Quality Control Check Report. Stage: After Column Casting (villas)

Block No.	52	Column No.	02	Sl. No.	32941
Company	SONCLIP	Project	SON	Phase	SE
Prepared by	P. Sai Kumar	Sign	PSK	Date	18/2/19
Project Manager	K. Ramesh Kumar	Sign	KR	Date	18/2/19
Previous stage report no.	32852	Report filed and signed by PM?		<input checked="" type="checkbox"/> Yes <input type="checkbox"/> No	
Checked By MD on		MD Sign		For filling

Description	Direction	Owners & Developers :	Date :	Promoted by
QUALITY CONTROL COLUMN POSITION CHECK PLAN TYPE-A1		Silver Oak Realty	10.08.2017	Modi Properties & Investments Pvt. Ltd.
		Project Name & Phase :	Prepared By :	
		Silver Oak Villas	Soham Modi	Phone: +91-40-66335551
		Scale :	N.T.S

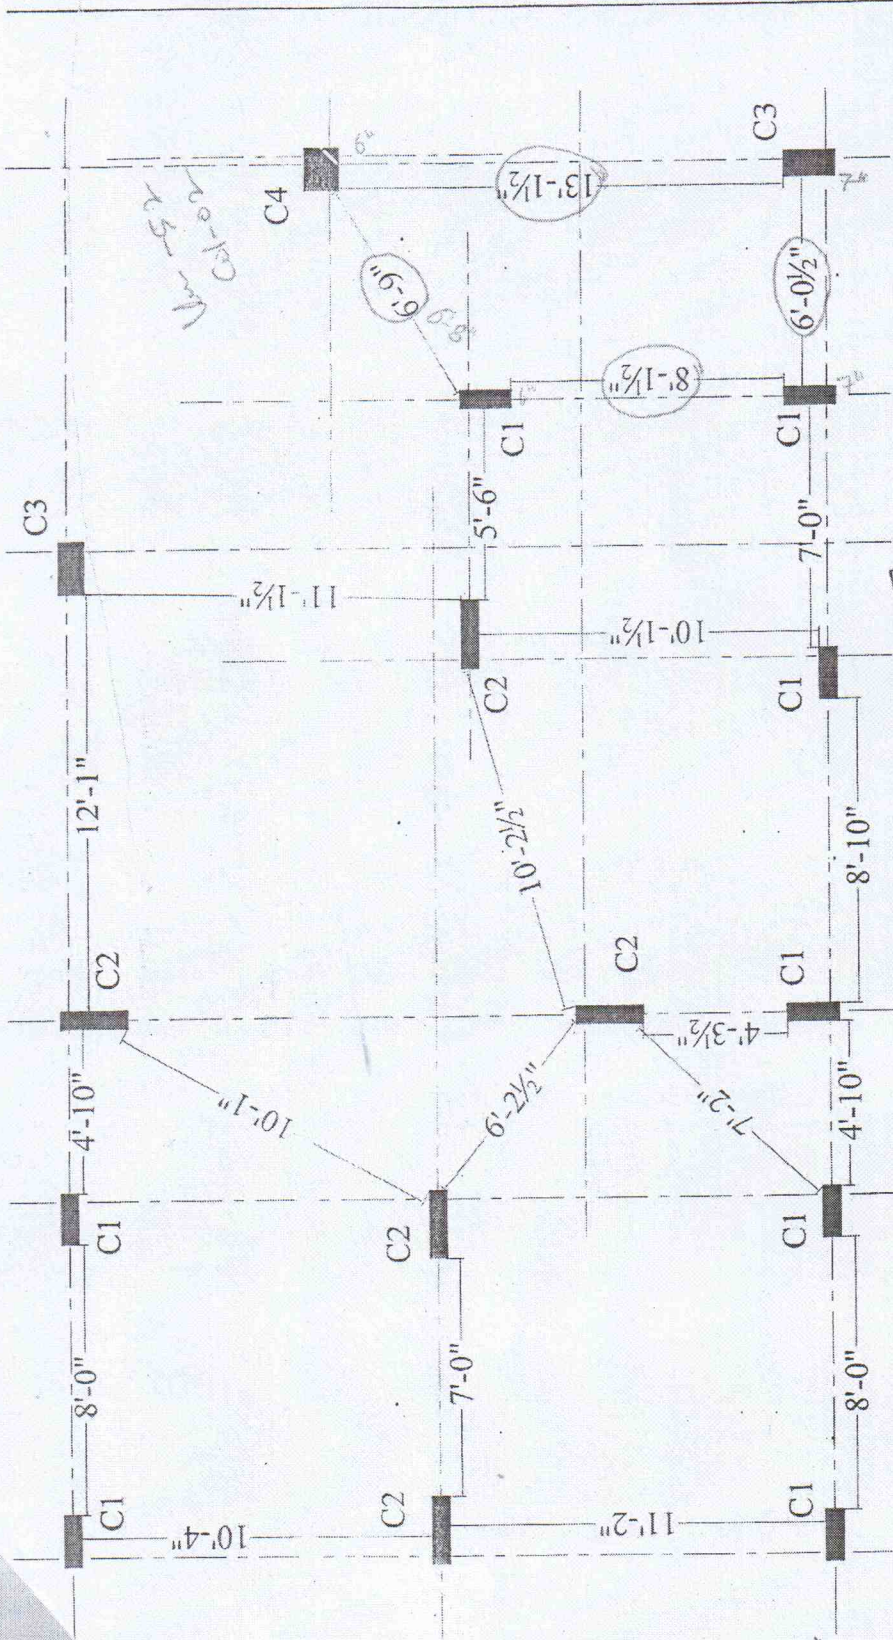
1.	C1	C1	8'-7"	8'-7"	✓	✓	✓	✓	✓	<input checked="" type="checkbox"/> Yes <input type="checkbox"/> No
2.	C2	C1	8'-7"	8'-6"	✓	✓	✓	✓	✓	<input checked="" type="checkbox"/> Yes <input type="checkbox"/> No

3.	F1	C3	8'-7"	8'-7"	✓	✓	✓	✓	✓	<input checked="" type="checkbox"/> Yes <input type="checkbox"/> No
4.	F2	C4	8'-7"	8'-6"	✓	✓	✓	✓	✓	<input checked="" type="checkbox"/> Yes <input type="checkbox"/> No

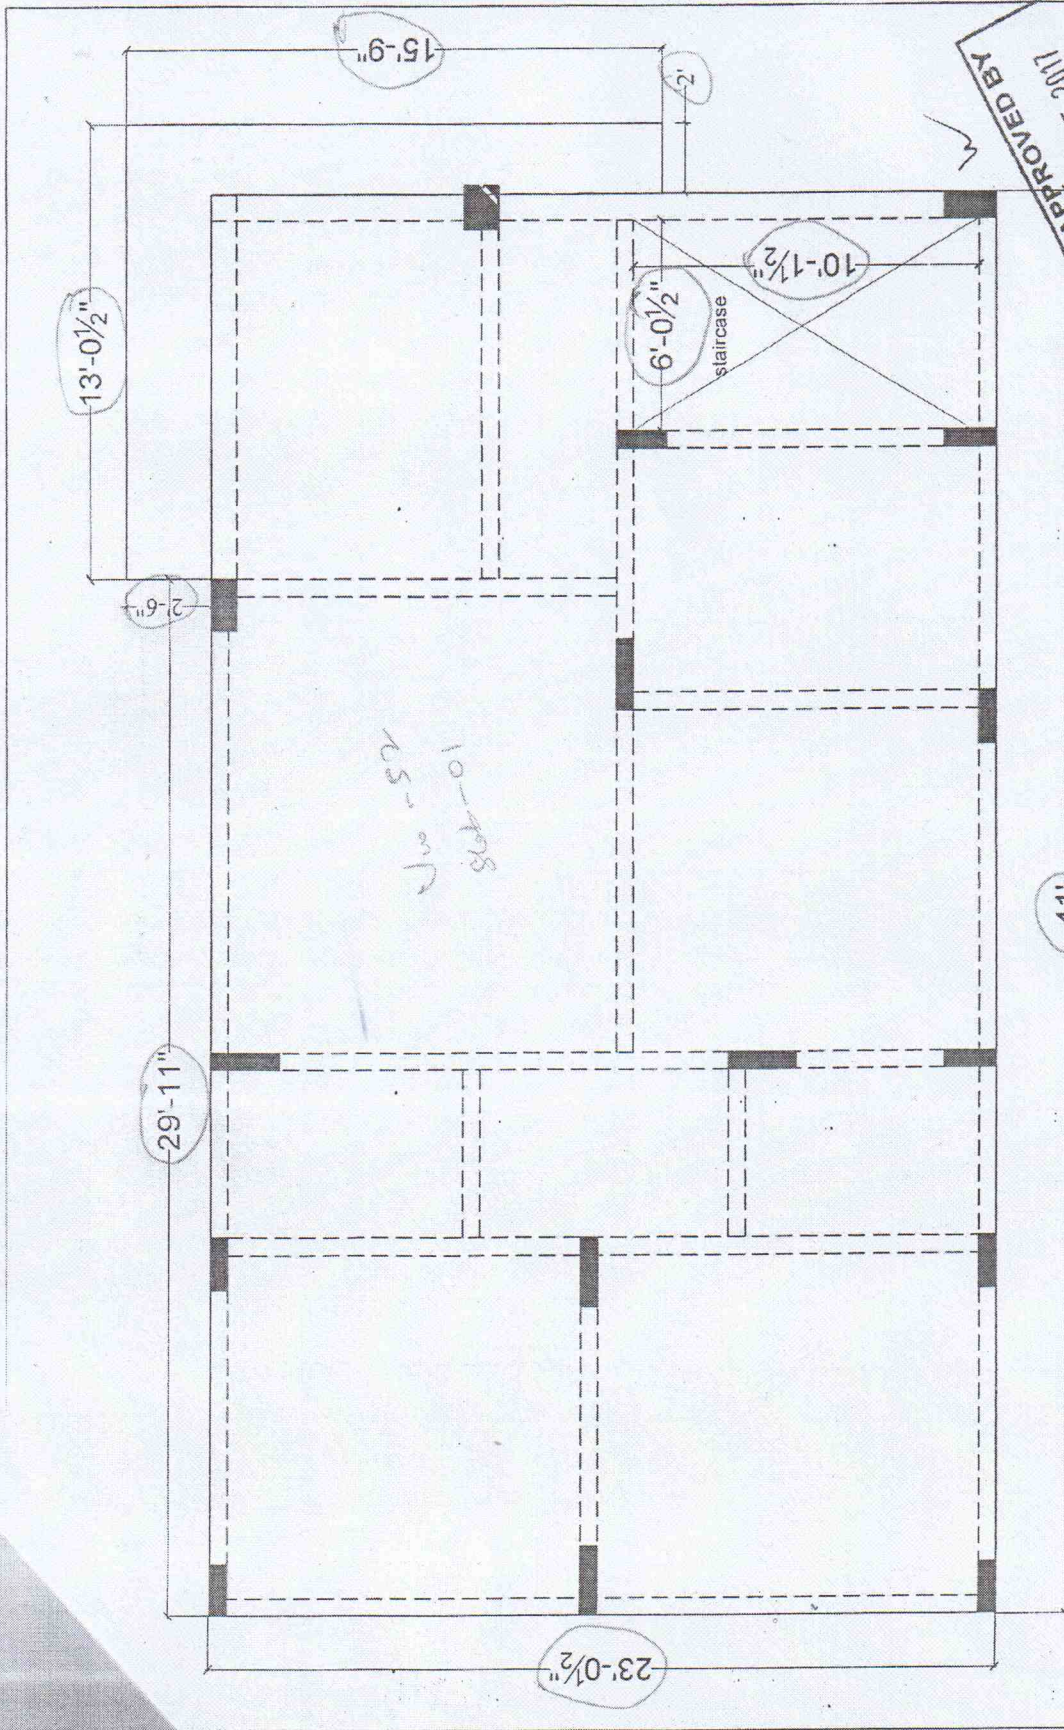
Specified thickness of slab? 5 1/2

Actual thickness of slab? 7 1/2
